RE: **Monterey Place Apts**  
**2306-2320 Central SW**  
**Conceptual Grading and Drainage Plan Stamp Date: 5/16/19**  
**Hydrology File: J12D030**

RE: Monterey Place (DRB - PR-2019-002331) Conceptual Grading and Drainage Plan

CONCEPTUAL  
GRADING AND  
DRAINAGE PLAN

C-101

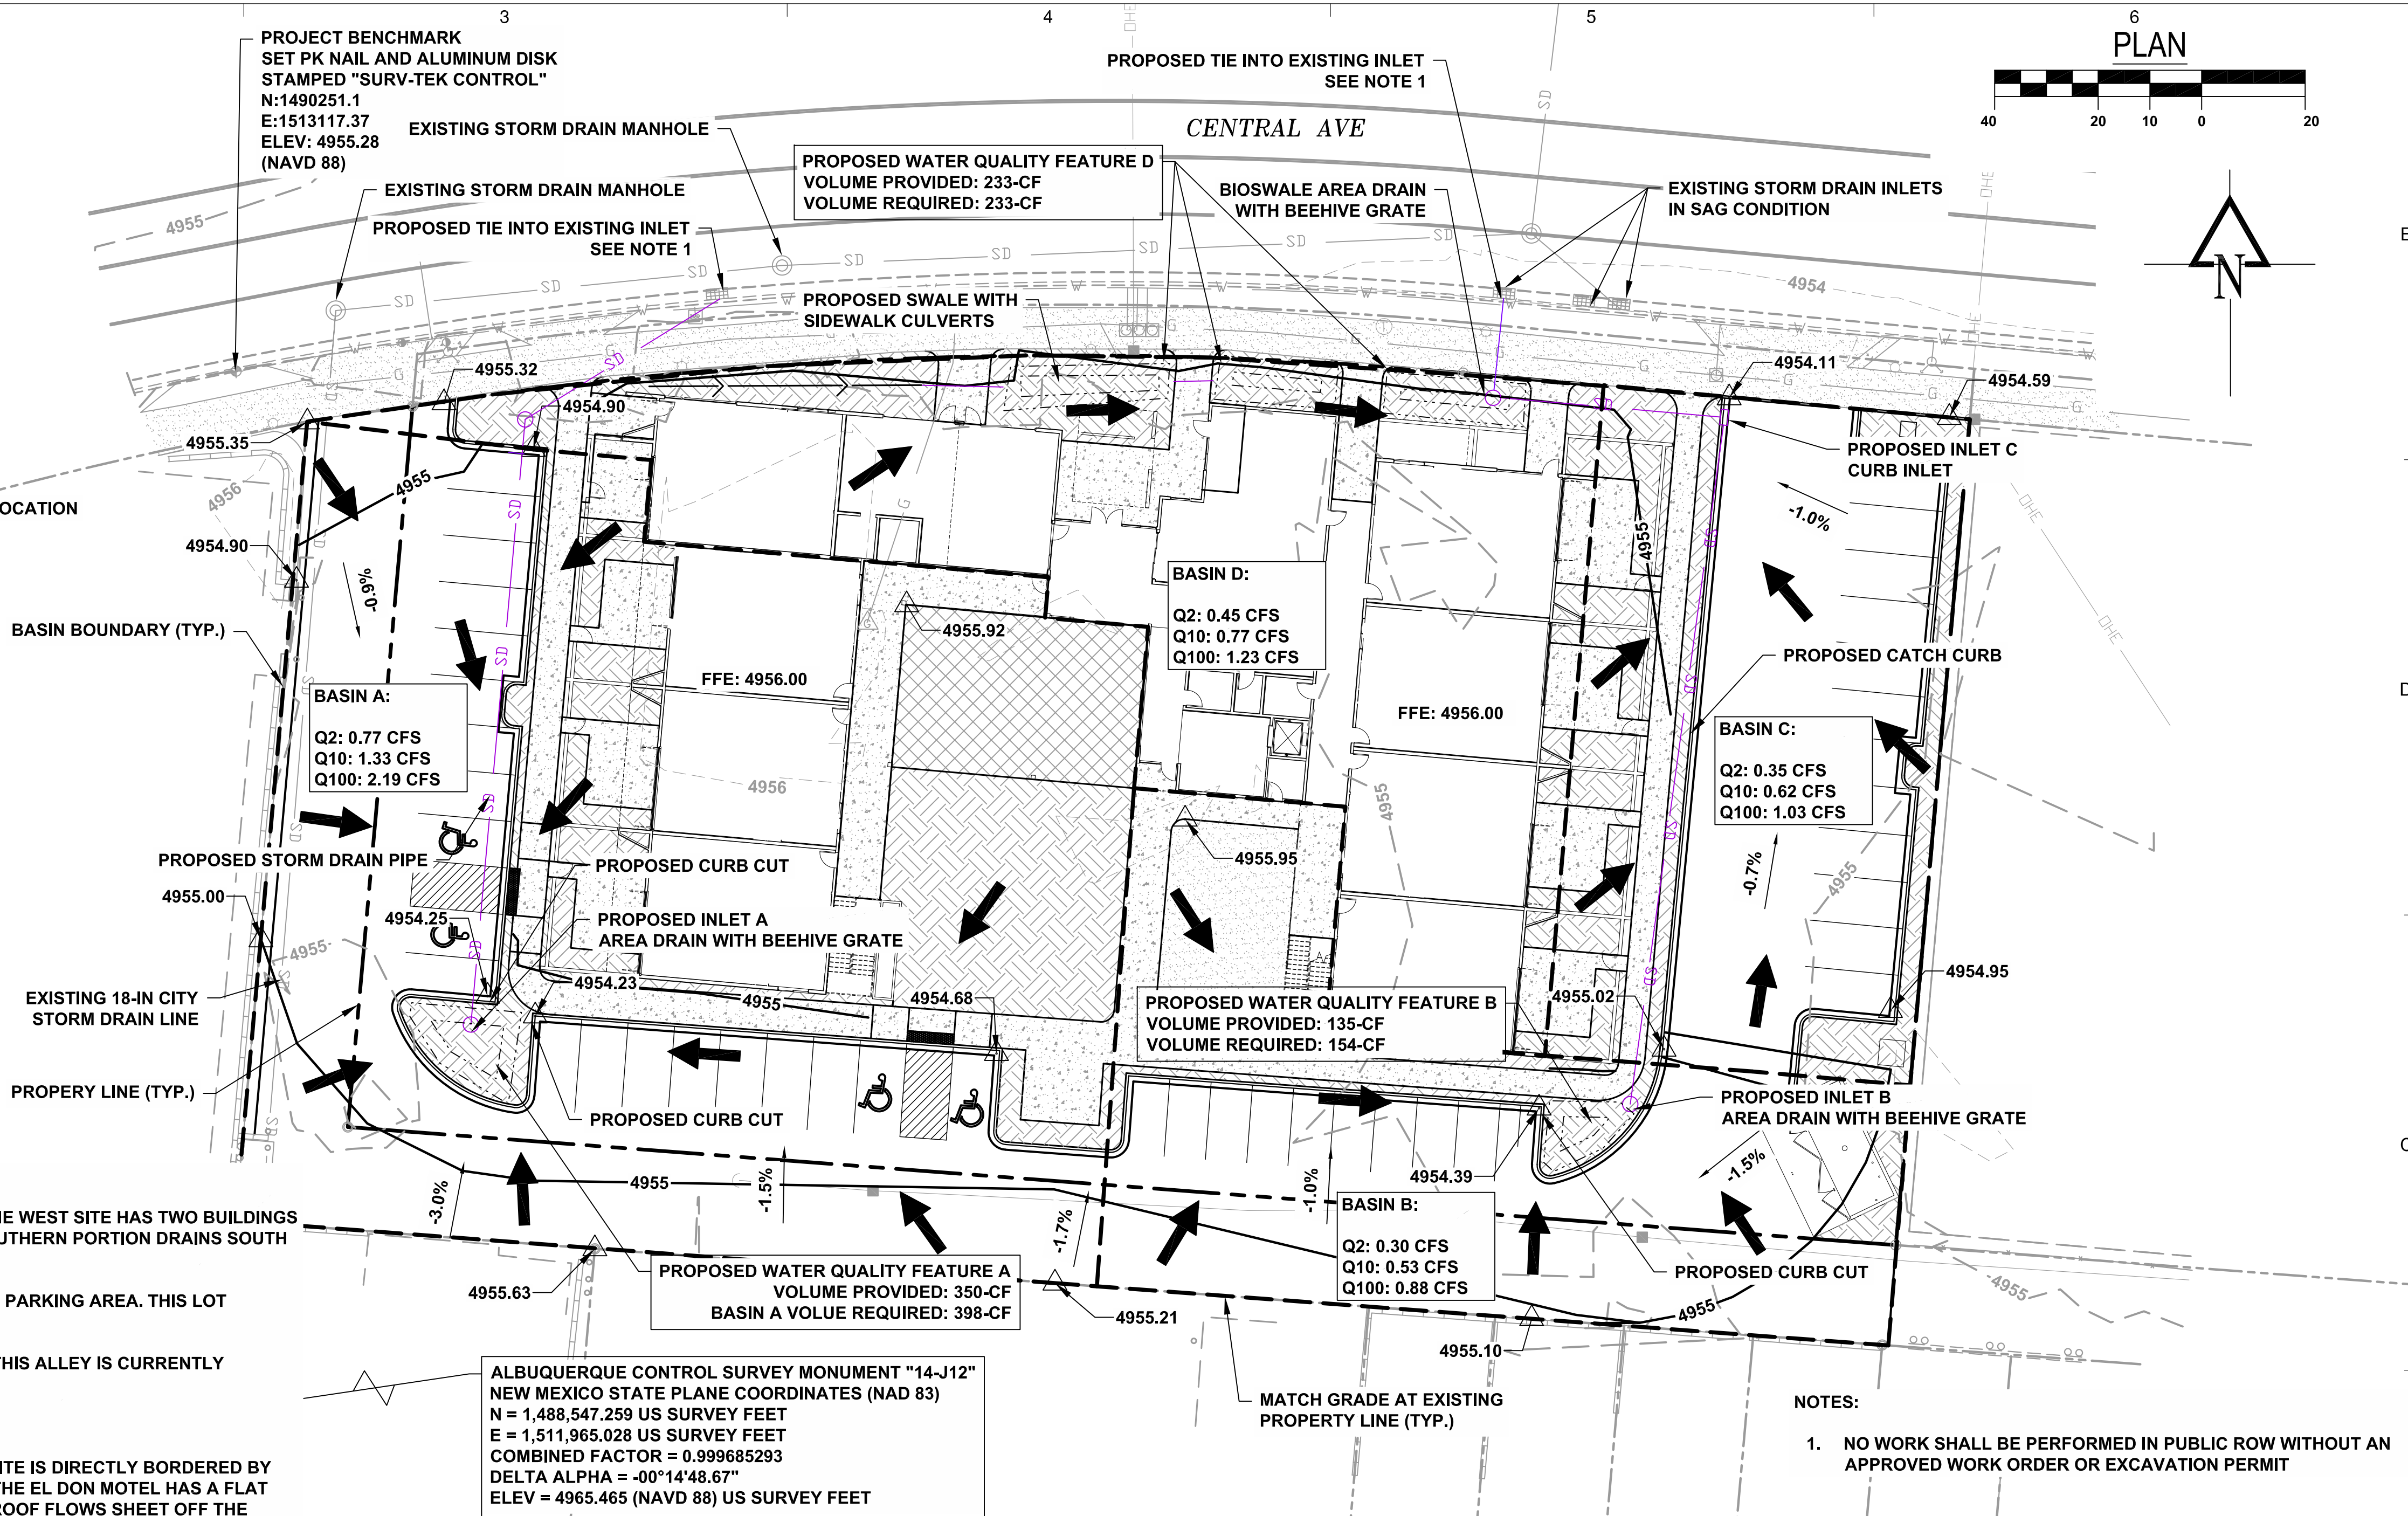
Based on the submittal received on 5/20/19 the above-referenced Grading and Drainage Plan is approved for Site Plan for Building Permit and Final Plat. On the Plat, provide a Public Drainage Easement (Blanket-exclusive of buildings), to allow the alley to drain into/through your site. Be sure to name maintenance responsibility and beneficiary.

1. Remove all "Conceptual/Not for Construction" markings.
2. Provide sections through the SWQ ponds and show the SWQV and water surface elevation (WSE). Also show the 100-yr WSE.

3. Provide hydraulic calculations for the new private storm drain calculated along the Energy Grade Line.
4. Provide hydraulic calculations for the beehive grates and curb cuts; the grates need to demonstrate 2x capacity (or 50% clogging) for the 100-yr storm.

5. Provide proposed spot elevations and contours in suitable density to discern all flow patterns across the project. The flow arrows/slopes are fine for the conceptual plan, but need to be replaced with elevations in the "For Construction" plan.

7. Payment of the Fee in Lieu (Amount =  $86CF \times \$8/CF = \$688$ , per sheet C-101) of onsite management of the SWQV must be made. Include a copy of the paid receipt when resubmitting.

8. Correct the error in table 4, Basin D, Fee-in-Lieu Area (906sf, not 0).
9. Additional comments may be provided at Building Permit, based on the outcome of the above remarks and level of detail shown on plans.

1. Discussion of existing drainage conditions is missing. Because no downstream capacity exists in this area, this development needs to demonstrate that it does not increase runoff overall (don't include the alley paving when looking at your site's increase as it is public ROW). Modifying the runoff pattern so drainage now goes to Central, instead of neighboring properties, is acceptable per our pre-design meeting.

2. Discussion of offsite flows is missing. Do any of the adjacent properties or the alley east of your site discharge to you property? If offsite drainage impacts your site, those basins need to be delineated, and your site designed to pass those flows.

3. The storm water quality volume (SWQV) should be calculated as 0.26" x impervious area (not 0.24"). Also, public ROW (the alley) does not need to be included when determining the required volume.

4. Because you are voluntarily treating the runoff from the public alley, you may use this volume to offset the bypass volume from Basin C; we just need a drainage easement- see below.

6. Ensure the bioswale (Feature D) provides 233cf of dead storage beneath the invert of the grate in order to claim credit for its SWQV.

7. The plan needs to be stamped, signed, and dated by a NM Professional Engineer. You should still label it as "Conceptual" or similar, until you have a "For Construction" Grading Plan.

8. The 3 storm drain connections along Central can be handled a few different ways:

9. Add note on the plan that "No work shall be performed in the public ROW without an approved Work Order or Excavation Permit."

10. Include project benchmark and datum.

A discussion and analysis of flows of the existing site was added to the revised plan. Overall runoff from the proposed development was found to be slightly less than the existing conditions when the public alley paving is not considered. Overall development flows are shown in Tables 1 and 2 of the revised plan.

A discussion of off-site flows was added to the revised plan as the final paragraph to the Existing Conditions section.

Calculations were revised to be calculated as 0.26". Thank you for catching this discrepancy. The public ROW imperviousness was not included in the revised calculations and the column was re-labeled as "Private Impervious Area"

The calculations in the table were revised to not include the public alley. RPE appreciates the opportunity to reduce the fee in lieu of based on these conditions. The "Fee-In Lieu of Area" is negative for Basins A and B to reflect this credit.

A public Drainage Easement will be included on the plat submitted to DRB.

The bioswale will be able to provide the required storage for storm water quality. Additional volume can be achieved by extending the bioswale west.

The revised conceptual plan has been stamped, signed and dated by a NM Professional Engineer.

This option will be pursued, and these connections will be included on the Infrastructure List.

This note was added to the plan as Note 1. References to the note were included in the "Tie into Existing Inlet" callouts.

This has been included on the revised plan.
